**VALUE ENGINEERING STUDY
FOR**

**UPGRADE
PUMP STATIONS 2 AND 3
JEFFERSON PARISH, LA**

DOD SERVICE: USACE
CONTROL NO: CELMN-VE-98-01
VALUE ENGINEERING OFFICER: Frank Vicidomina

The Value Engineering Study was conducted in the New Orleans' District Office during the week of 6-10 October 1997. The study was based on the Concept (50%) Design Submission Reports, dated October 1997.

DRAWING NO. 1

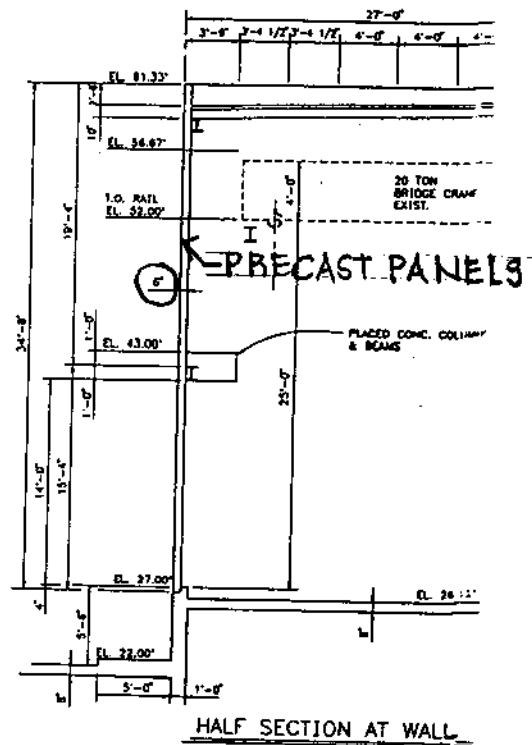
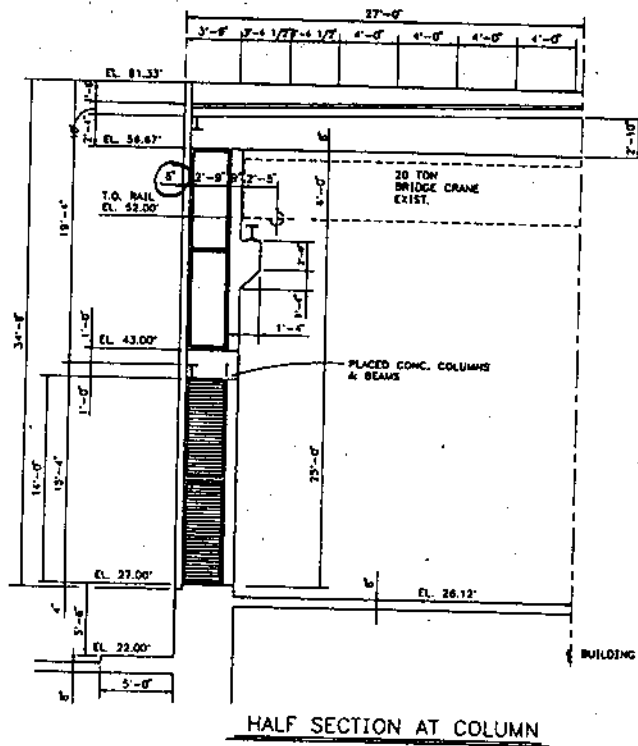
The current design shows 6" thick non load-bearing precast concrete wall panels. The panels are attached to the building's structural framing system (see Drawing Nos. 1 and 2).

Recommend 4" thick panels be substituted for the 6" thick panels.

1. For non-loading bearing panels of the face dimensions shown, 6" appears slightly thicker than needed. The precast panels on this building are architectural panels with no structural load carrying requirements other than wind load and selfweight. It is structurally feasible and common in industry practice to use 4" thickness for this type of precast panel. Also, acceptance of this proposal reduces the dead loads the building frame will need to support due to the reduced panel weight, and may result in a reduction in the size of structural support.
2. Reduces construction costs.

DRAWING NO. 1

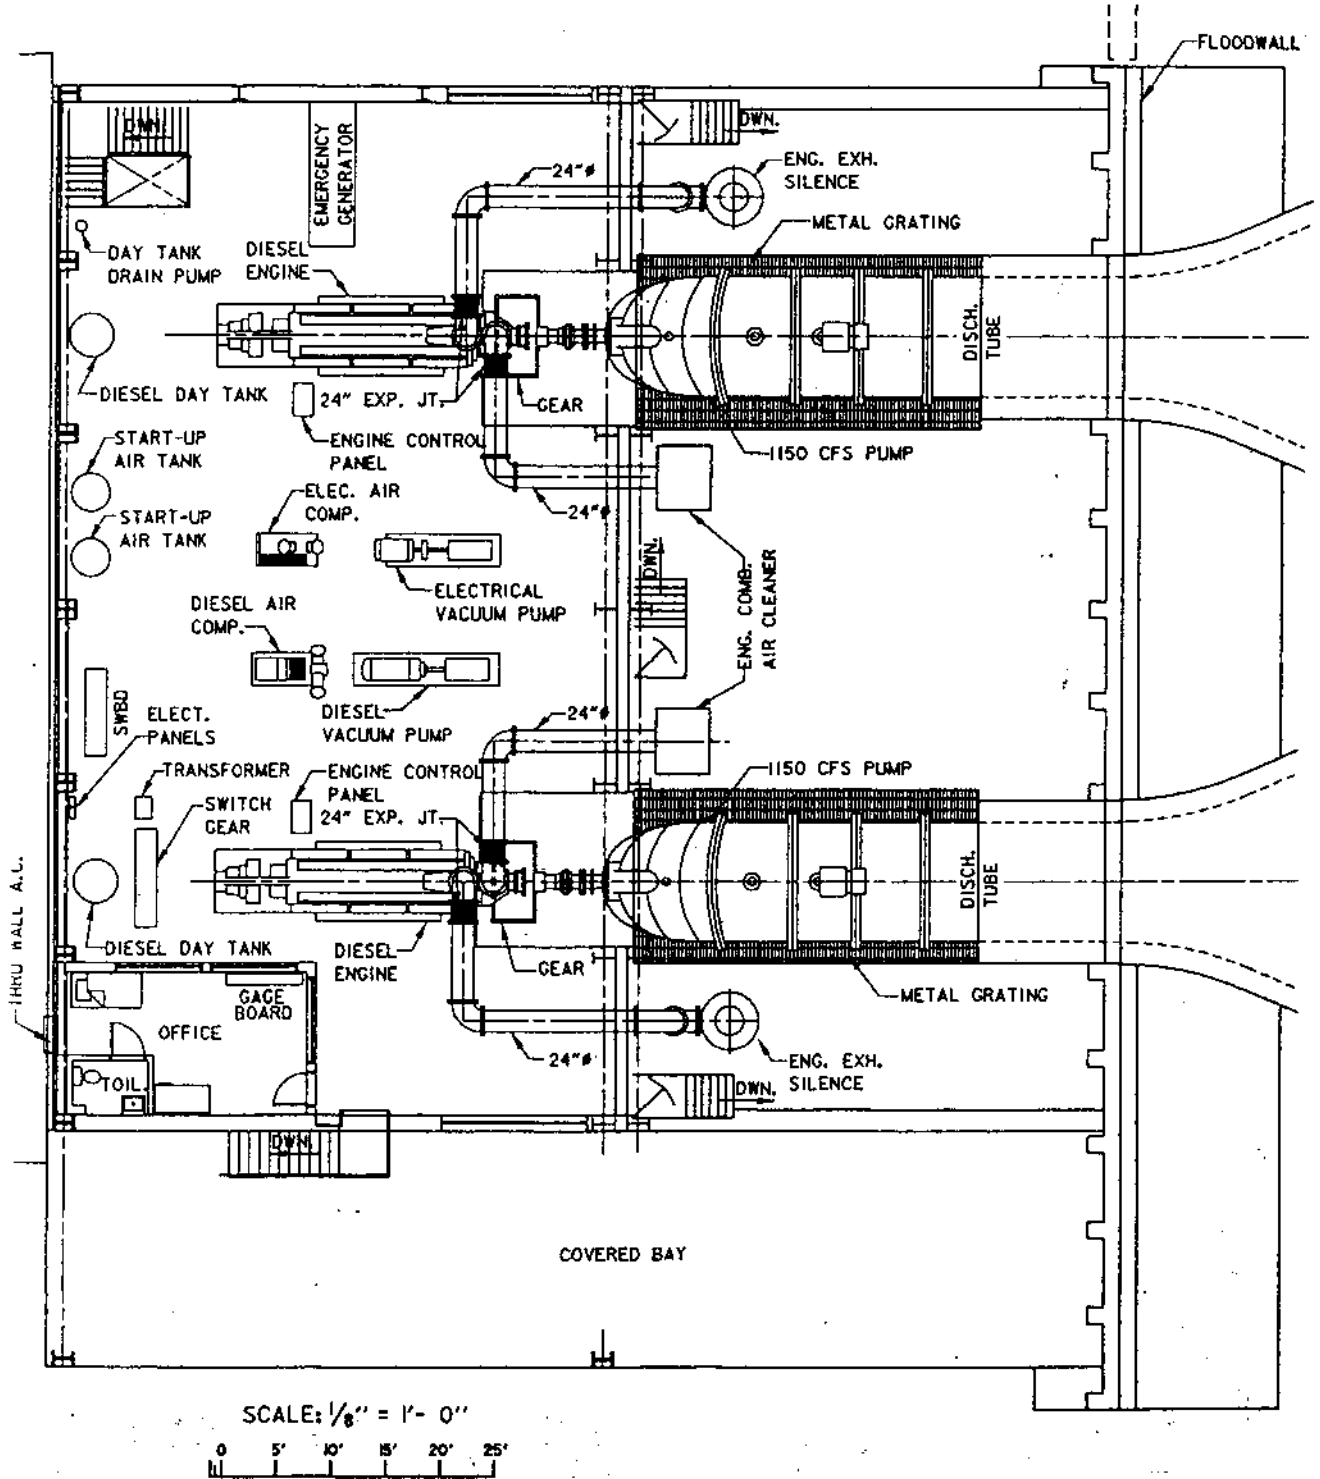
The current design locates the combustion air intake filters on the exterior of the building and transports the air to each engine via 24" diameter pipes (see Drawing No. 1).

This proposal recommends mounting the intake filters on the engines and eliminating the 24" piping (see Drawing No. 2). The combustion air will be drawn from within the plant.

DRAWING NO. 1

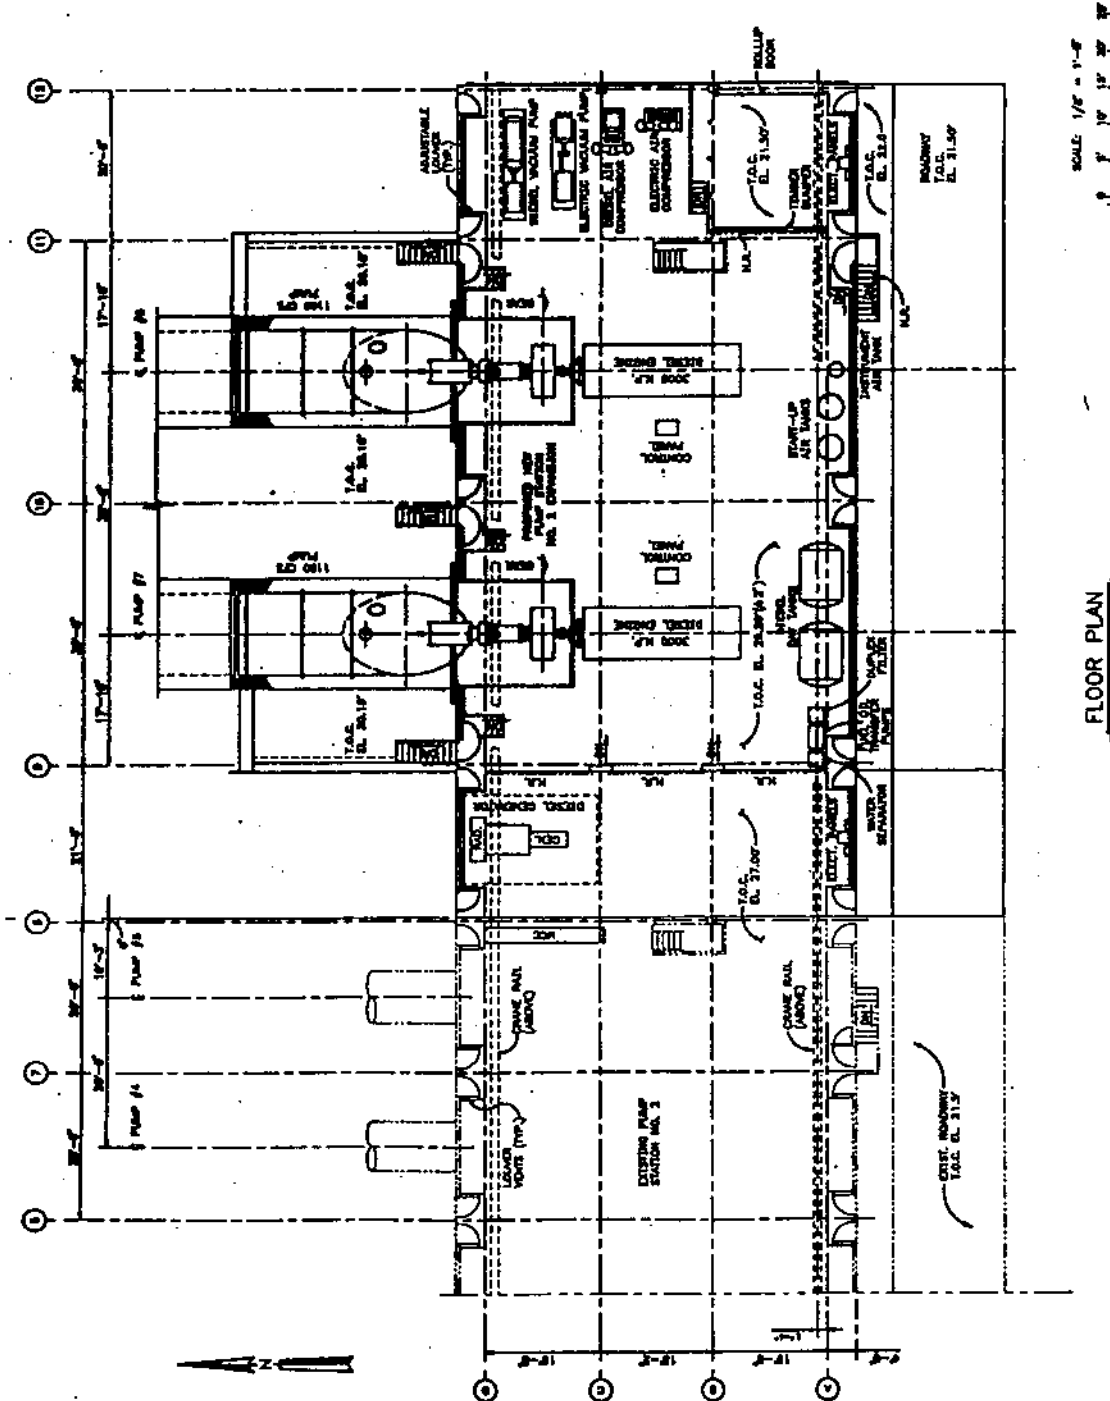
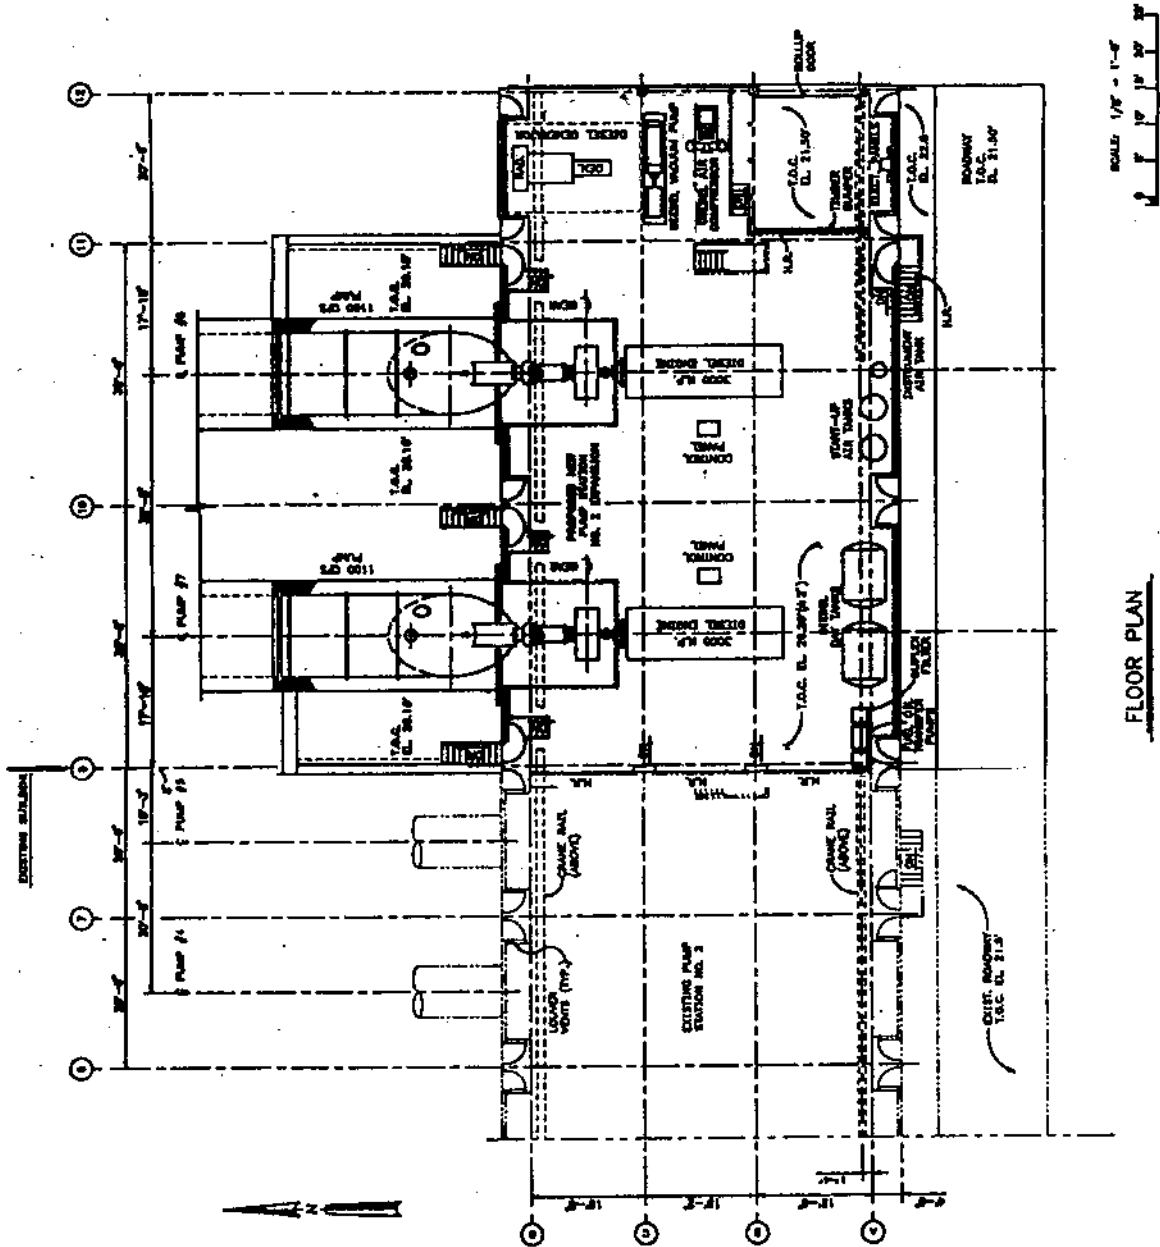
The current design includes the two new vacuum pumps, two new air compressors and a new emergency generator. The generator is in a dedicated bay (see Drawing No. 1).

This proposal recommends deleting the electric motor-driven vacuum pump and the electric motor-driven air compressor. This proposal also recommends relocating the emergency generator and eliminating the bay which currently includes the generator (see Drawing No. 2).

With one new vacuum pump and one new air compressor, plus the existing two vacuum pumps and the existing two air compressors this plant should never be without startup air or primer pumps.

DRAWING NO: 1

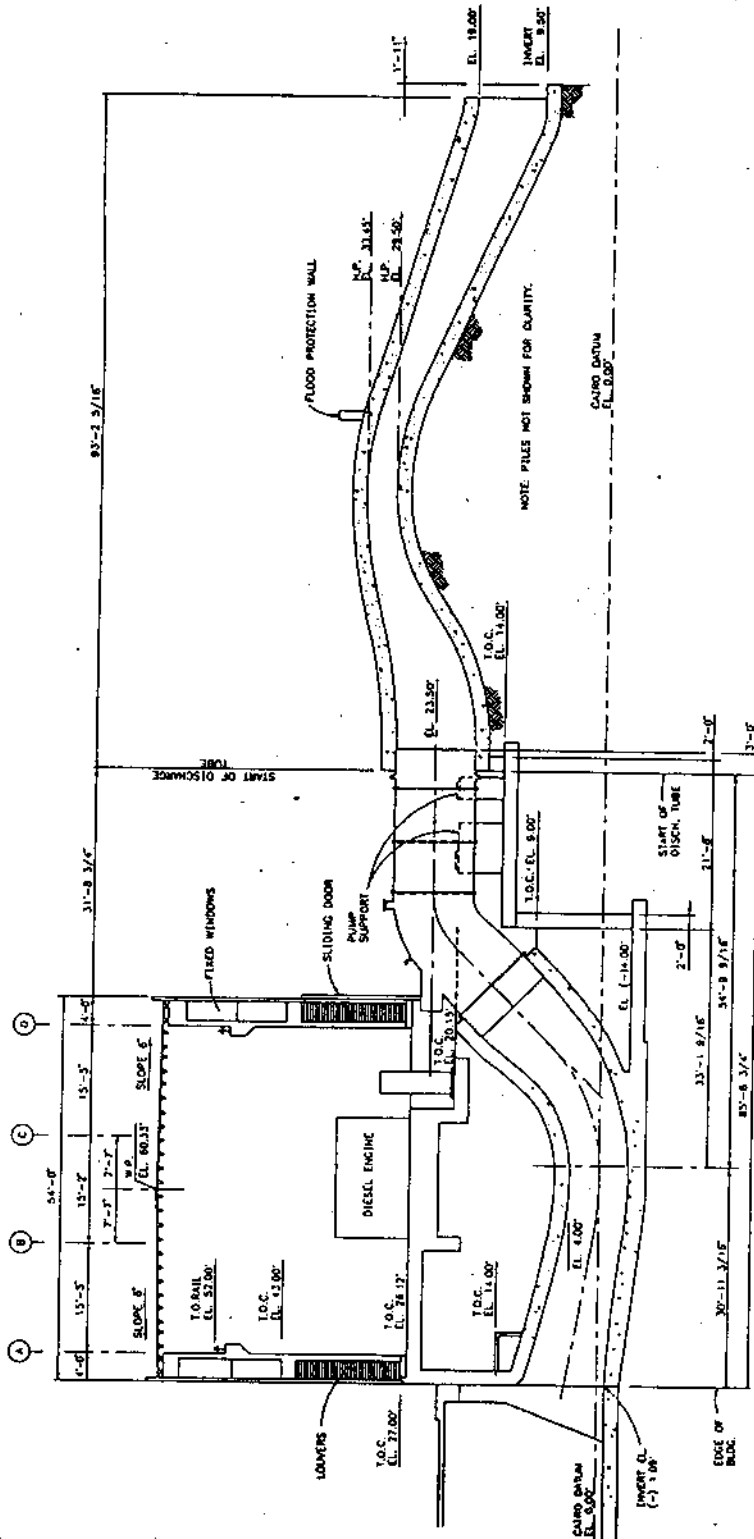
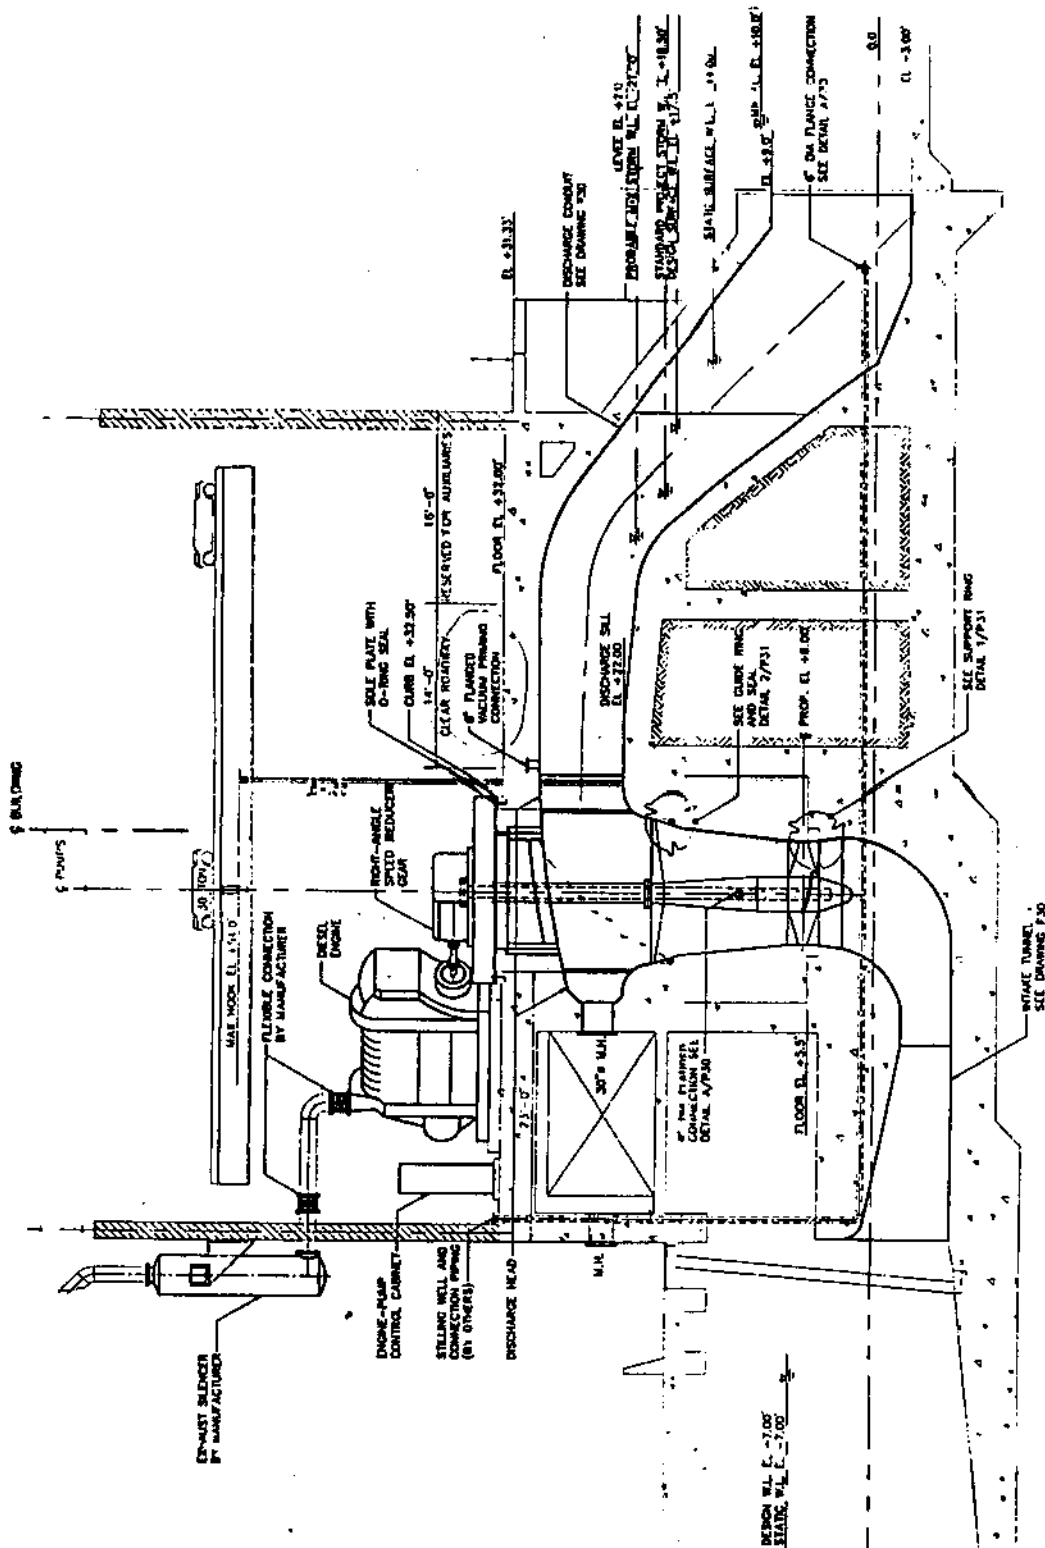
The current design intent is to add two 1200 CFS pumps to the Suburban Canal Pumping Station (Station No. 2) and two 1200 CFS pumps to the Elmwood Canal Pumping Station (Station No. 3). The pumps and diesel engine drivers are not included in the design package for these two pumping stations. These pumps and drivers are planned to be government furnished equipment and purchased under a separate contract. The pump contract will purchase seven horizontal pumps which have been specified around the ITT-Allis Chambers model WCXH-132. Two of these pumps will be installed at Pump Station No. 2, two at Pump Station No. 3 and the remaining five at other pump stations. The expansion for these two pump stations has been designed around Jefferson Parish's decision to use horizontal pumps with diesel engine drivers (see drawing no.1). The existing Pump Station No. 2 includes a combination of horizontal and vertical pumps. The existing Pump Station No. 3 consists of all vertical pumps.

This proposal recommends that vertical pumps be considered in the design process for these two projects. With the proposed configuration, a diesel engine would drive the pump via a right-angle gear reducer (see drawing no. 2). The vertical pumps could be specified around an Ingersoll Dresser model -111 APS or equal.

Given the relative advantages and disadvantages of vertical verses horizontal pump installations it would appear that the significant first cost difference associated with horizontal pumps would only be justified in a high use/high maintenance application. This is far from the project situation. These pumps are not expected to run much more than fifty hours per year. Such limited use indicates minimal fuel consumption and infrequent major maintenance. In fact, past history in the project area has shown that the existing vertical pumps in service have seldomly required major maintenance. While there is no doubt that maintenance, when required, would be easier for the horizontal pumps, the substantial first cost savings associated with vertical pumps far outweighs the expected infrequent maintenance savings of the current plan.

1. Reference the COST ESTIMATE WORK SHEET for Proposal M-6.

a. Based on a recent procurement action for 1,200 cfs horizontal pumps, the average cost of the pump was \$816,000. This is \$56,000 more than the cost used for vertical pumps, or \$392,000 for seven pumps, versus the \$4,900,000 claimed. Further, the vertical pump would require a right angle speed reducer versus a straight HOL speed reducer used on the horizontal pump. The right angle gear would have to carry the pump rotating weight, plus the hydraulic downthrust. The size of the thrust loads would be high (as much as 160,000 lbs.) This would add as much as 15% to 20% to the speed reducer costs (\$50,000 to \$60,000 per pump), offsetting the first cost savings on the pump purchase.

1) The weight of the vertical pumps is significantly higher than (perhaps as much as twice) that of the horizontal pumps. It is questionable that any significant reduction in structure costs could be realized given the greater foundation requirements.

Based on the limited cost differential of the pumps, the offset cost with the thrust loads, and the questionable and unsupported differential in installation and formed suction/discharge costs, there would appear to be no first cost advantage to using vertical pumps.

In view of the fact that: (a) the first cost savings on the units are not realized; (b) the differential in installation and formed suction/discharge costs are not supported and, in fact, are disputed; and (c) the higher life cycle costs of operation and maintenance are acknowledged, there appears to be no justification for the change to vertical pumps. Further, while there would be significant cost increases associated with changing to vertical pumps from horizontal at this point in time (re-design costs, delayed benefits costs, claims for proposal preparation costs associated with the canceling of the current solicitation, etc.), the information presented herein supports the conclusion that, even without those cost increases, there is no significant advantage, cost or otherwise, to the use of vertical pumps over horizontal in the applications associated with this project.

DRAWING NO. 1

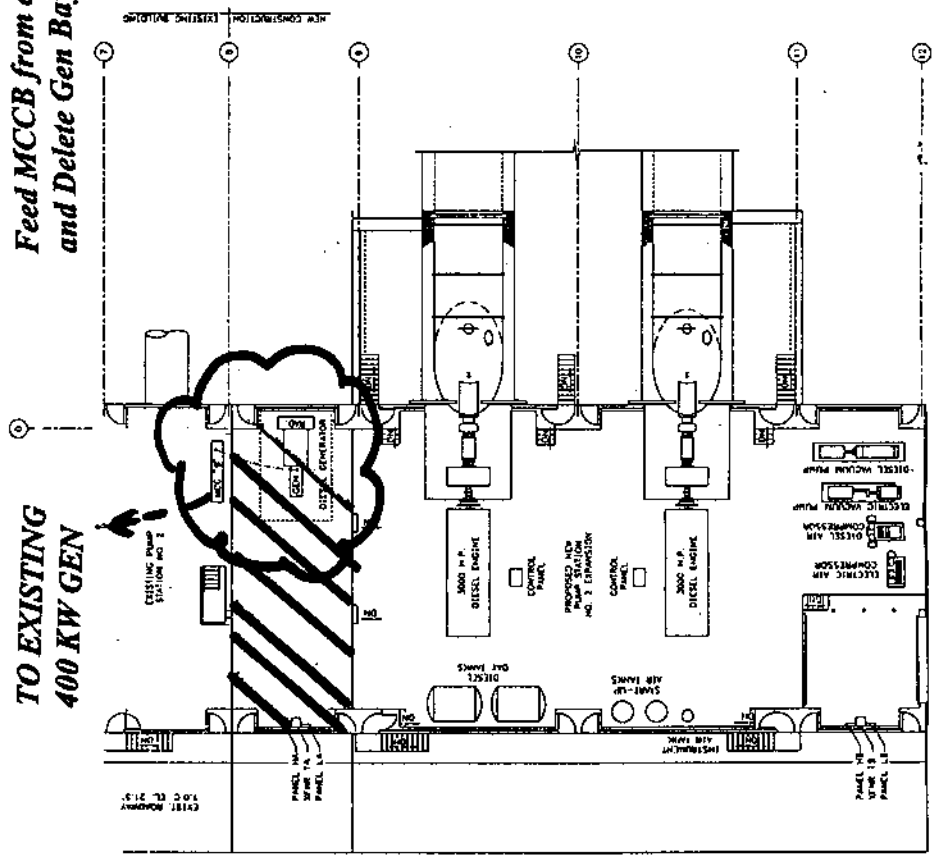
Feed MCCB from existing 400KW Gen
and Delete Gen Bay
